## **PLAN REVIEW SHEET**

2013-060 Land Net LLC Telephone:

**Shelter Pad Details**

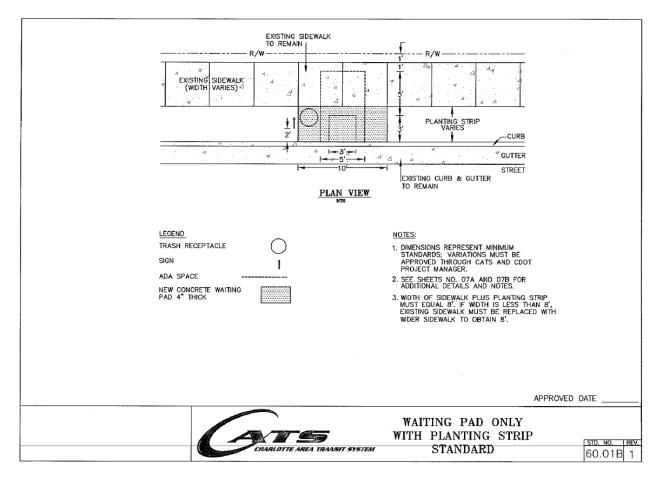
The Petitioner is requested to provide and construct a concrete waiting pad for the existing bus stop along Steelecroft Parkway. The pad needs to be located between the site's side walk and curb along Steelecroft Parkway. Below is an image of the standard detail (60.01B) for the pad.
